POTENTIAL TO FLOW (DETAILED) SECTION

Key results for Potential to Flow are summarized in Table 1 Modeling Table in section 3.2 of the main body of the Report and in the Attached full version of the same Table.

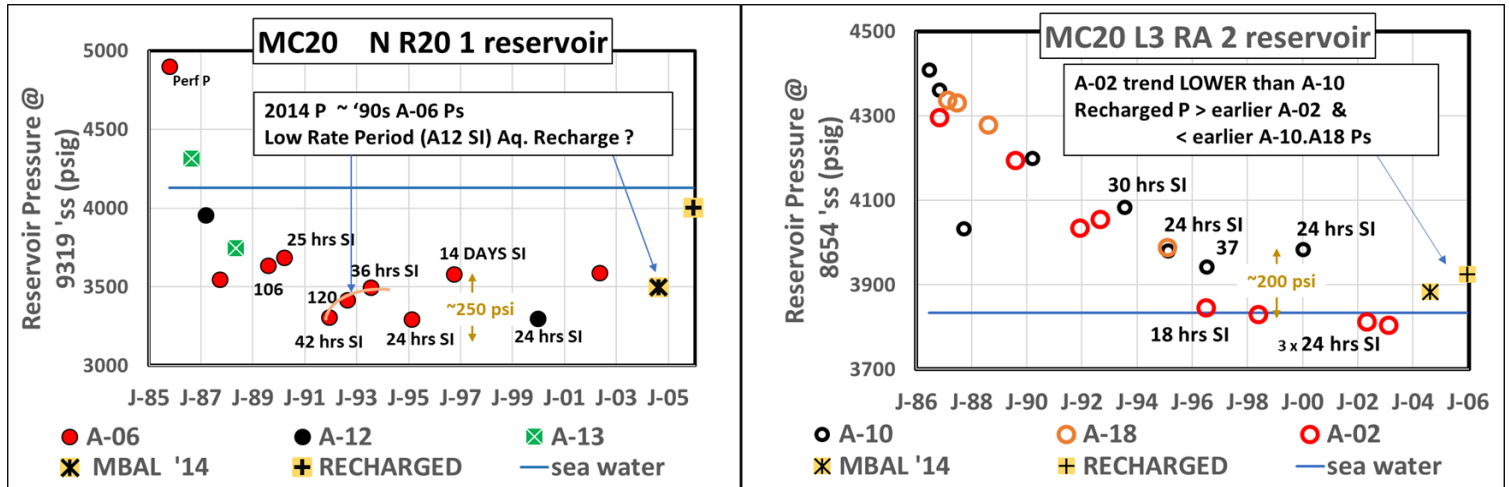
Figure 1 contains the Historical Reservoir Pressure data reported in FRACE for the NR20-1 and the L3 RA-2 sands. Visual inspection of this data indicates a scatter of about 200 – 250 psi (5 – 8 %) in the pressure depletion trends for a given well or for the overall Tank. Furthermore, there appear to be two Pressure trends for L3 RA-2: a lower one for A-02 and a higher one for A-10 (with very few points for A-18). This would indicate that the reservoir may be better represented by two tanks with a leaky connection between them, a case that can also be modeled in MBAL but was not shown in FRACE.

Based on the scatter of the Reservoir Pressure data in M-20 (**Figure 1**) and on experience with similar unconsolidated high-quality reservoir sands in Gulf of Mexico, for **Task 8 and Task 9 a +/- 10% range was used, as a conservative uncertainty around the Cobb et. al. single deterministic Recharge Pressure estimates**. In fact, variability in results of +/- 20 % or even +/- 30% could be expected from a full sensitivity analysis, given the sparse data set available and the possible ranges and uncertainties for all parameters and inputs. This would be especially the case as in L3 RA-1 where the data indicated two interconnected tanks as a possible alternate representation vs. the single tank used.

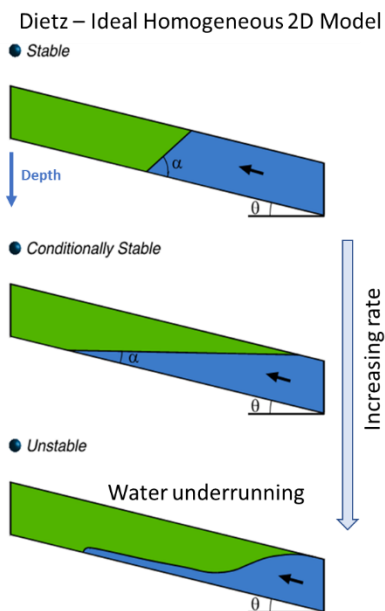
would look like in a perfectly homogenous (ideal) high quality 2D reservoir, allowing excellent segregation of fluids, is presented in **Figure 2**. This is the standard Dietz model originally developed for application in the high-quality North Sea sands, decades ago. Note that even in this ideal fully homogeneous case, for any commercial level extraction rates, **flow is almost always unstable** and water tends to underrun as in the bottom image.

- Water encroachment in actual reservoirs does not generate a planar surface water-oil contact sweeping 100% of the movable oil as it moves up-dip (Figures 2 and 3)
- For very high-water rates, the ratio used to track water vs. oil in a producing well or field is NOT water cut but Water Oil Ratio ($WOR = \text{rate of water} / \text{rate of oil}$), which approaches infinity (100 % water) only as the oil rate approaches 0. In actuality, even at extremely high WORs a producer will deliver some oil with the produced water, **this is a basic concept that any professional in the field with even limited experience in handling produced water would know.**

Figure 1 2D cross section cartoon of a "realistic" high quality sand reservoir somewhat analogous to the sands in M20. At the top the colors represent Porosity, with RED = highest porosity (and quality) and BLUE being low porosity (and basically no permeability).

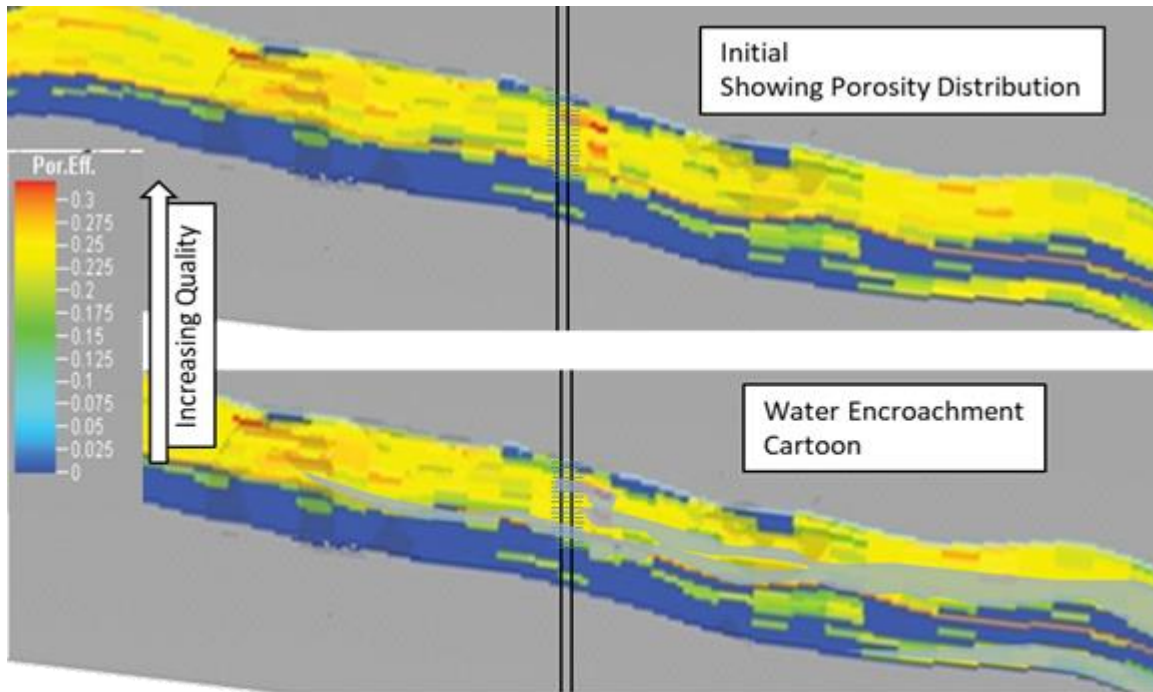
A more realistic looking cross section of water encroachment with heterogeneities, is presented in **Figure 3**. This illustration of complex water encroachment is the type of behavior that takes place in high quality but not ideally homogeneous reservoirs such as MC-20. Segregated flow would exist within pockets of contiguous high-quality rock. There would also be barriers and poorer quality rock pockets isolating or delaying water entry, as well as high quality streaks acting as thief zones for water to preferentially run through. As illustrated in **Figure 3**, after some depletion a well may see oil above water above oil in its perforated interval. Without specialized in-well surveillance, any estimation of water inflow distribution over the perforated interval at a given time is at best an educated guess. Additionally,

Furthermore, water rich areas as in **Figure 3** and as in MC-20 are seldom 100% water with no remaining local movable oil. Displacement down to irreducible oil saturation requires a huge number of pore

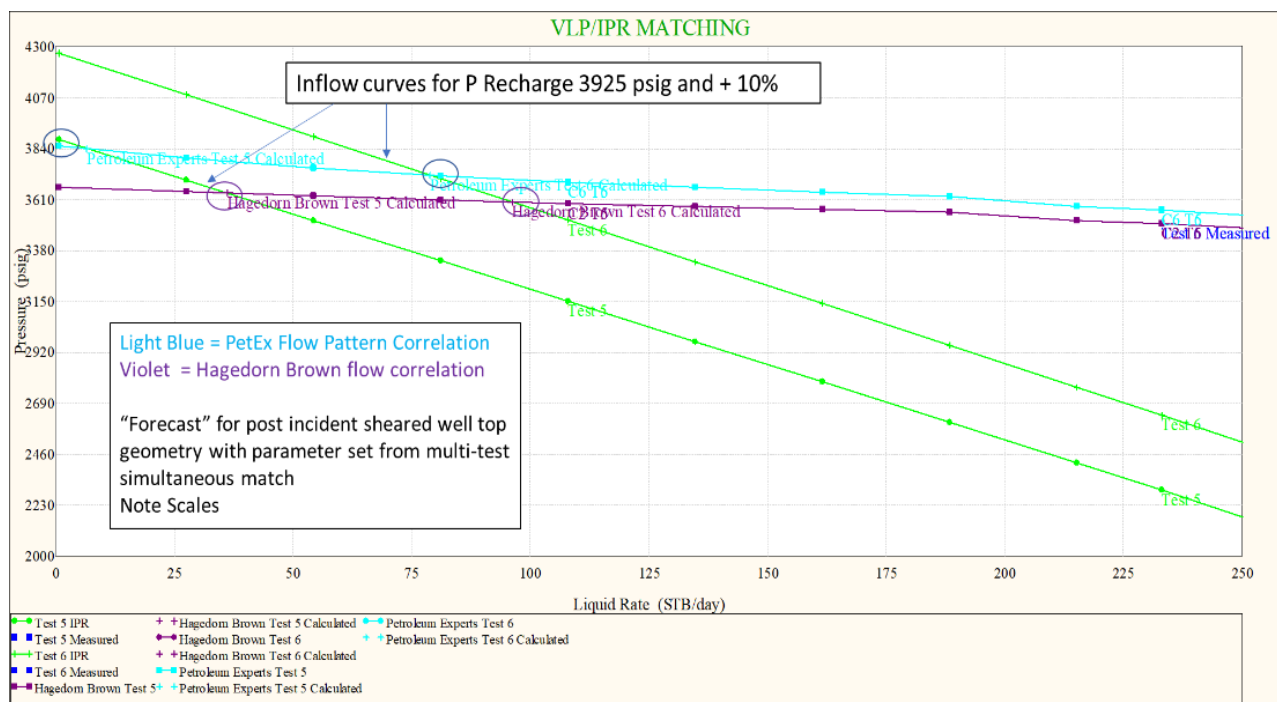
Results are shown in **Figure 5** and are summarized and compared with FRACE in the table that follows:

In conclusion, when considering input variabilities, it becomes quite difficult to conclude that Nodal Analysis conclusively indicates the A-02 well has no potential to flow.

As stated previously only small differences were found when matching the 4 tests simultaneously selected for A-02 with either of the flow pattern correlation tested (Hagedorn-Brown and Petex). However, all the calibration tests are for relatively high liquid rates (commercial producing wells with lift). For the smaller rates of **Figure 5** (no lift), the choice of flow correlation makes a difference.

Figure 6 Regulator Reported Test data for well A-06. Note Log scale, ups and down is reported GOR and significant GOR drop after Gas Lift started

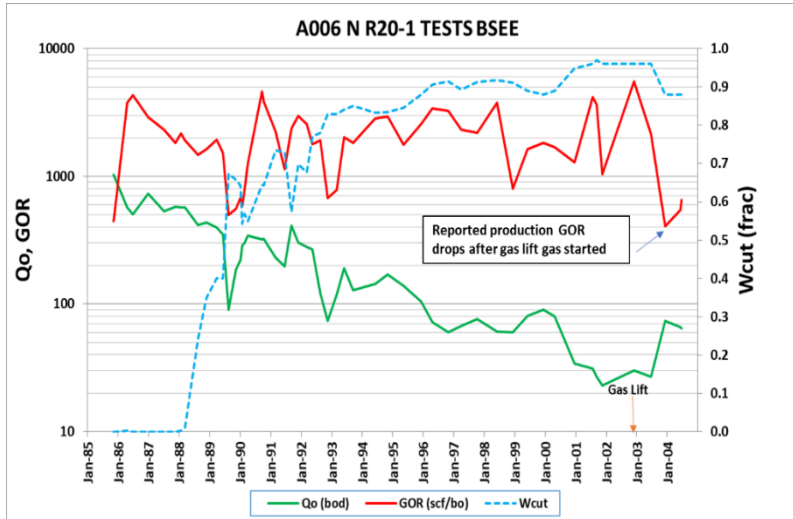
As the Sept-1987 test did not trend with the others, it was dropped. There appears to have been a well intervention or workover after this test and before the next test in 1990.

Figure 6 shows all the A-06 flow test as reported to the Regulator for the life of the well:

- A-06 had a relatively high and quite variable Gas Oil Ratio (GOR) reported for most of its life. This GOR behavior appears related to the N sand having an oil leg and a gas cap; this is also an indicator of variability in the reservoir gas

- There was a significant reduction in reported GOR after gas lift was started in late 2002.
- The frequency of testing was about once every 6 months; which would affect the allocation calculations if there were significant changes in actual well behavior within the 6 months.
- For the vast majority of these tests, not enough data was measured or reported to use as viable calibration points for any realistic accuracy with Nodal Analysis.

Figure 7 Nodal Analysis charts. Simultaneous matching of the four A-06 Tests (3 + Sept-04 reconstructed), leading to a Skin of 21. The green lines are the inflow performance results and the violet lines represent the tubing performance

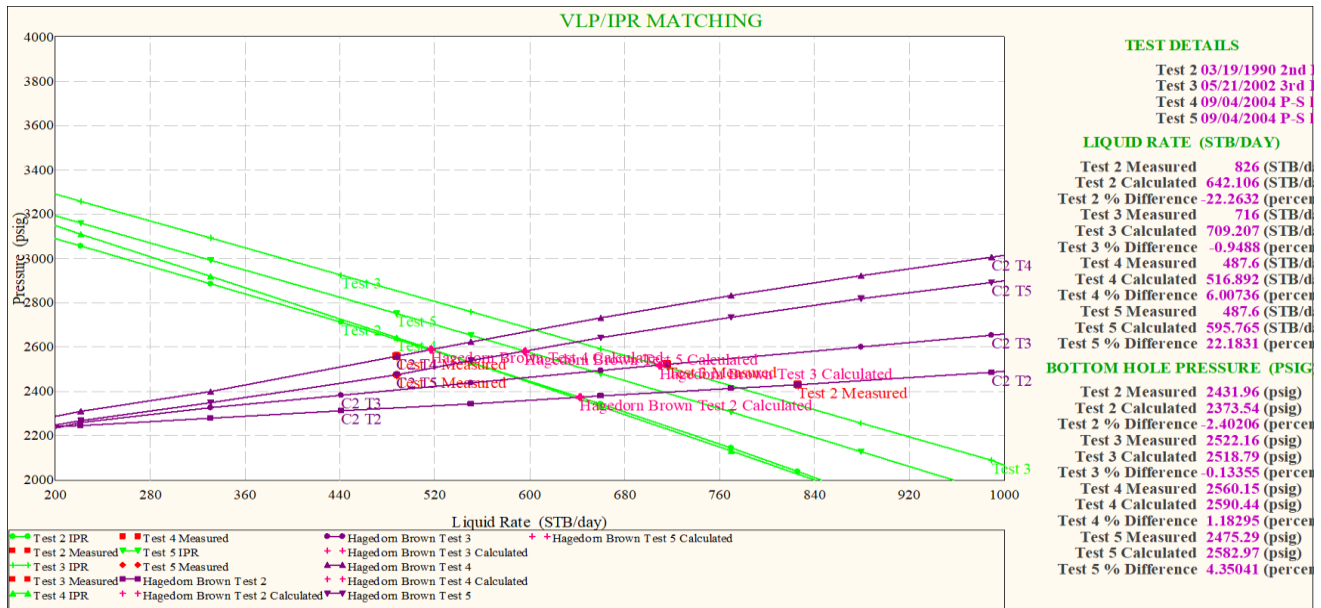
Figure 7 shows Nodal Analysis charts for the Simultaneous Match of 4 tests Well A-06; 2 field tests (Tests 2 and 3 shown in chart) and the Late “reconstructed” test twice : once (Test 4 in chart) with the test data gas as in FRACE, and the other (Test 5 in chart) with the sensitivity in the Gas lift/ Reservoir Gas

in Table 1 (case 4). The matches are all quite close (1 – 20 % mismatch in liquid rates, 2 – 4% mismatch in flowing bottom hole pressure). Note the relatively small changes due to the sensitivity in the Gas Lift Gas / Reservoir Gas allocation. The match led to fixing the Skin factor for the whole of the completed interval as ~ 21 for all tests (which represents approximately a 3 fold reduction in influx vs. no skin). This compares to the skins of 15 for the Early test and 21 for the Late (reconstructed) test, each one matched individually in FRACE -Platt-Sparks.

Rate / flow ratios sensitivities were conducted on well A-06 and it was found that switching just 20 Mscf (~10 %) of the reported gas lift gas to produced gas, keeping the overall gas amount constant, made a significant enough difference in the Nodal Analysis results from a No Flow to a Flow case. These changes are reflected in the Sensitivity_lines in Table 1 for the Late (reconstructed) test (Case 4) and the Forecast post-incident (Case 6).

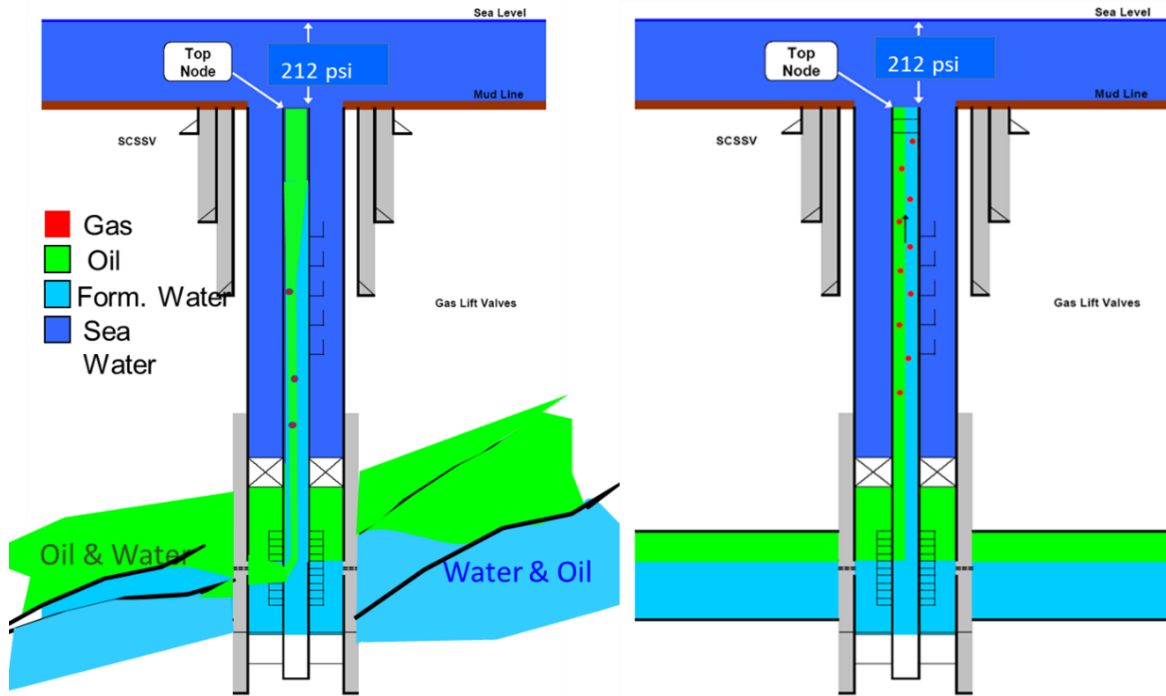
The left side of **Figure 9** illustrates the possibility that only a small part of the completed interval would flow, as well as the partially segregated distribution of oil and water in a heterogeneous reservoir

around the well after a period of low or no production. It is compared with a more idealistic representation from the FRACE report on the right, with a homogeneous reservoir and whole perforated interval flowing.

Once the possibility of one or more individual streaks of the whole reservoir at the completion is flowing is accepted, the whole Nodal Analysis approach as used in FRACE to forecast possible low flow

rates in the M20 wells post incident loses most of its value. It becomes a conceptual model that may not apply at all.
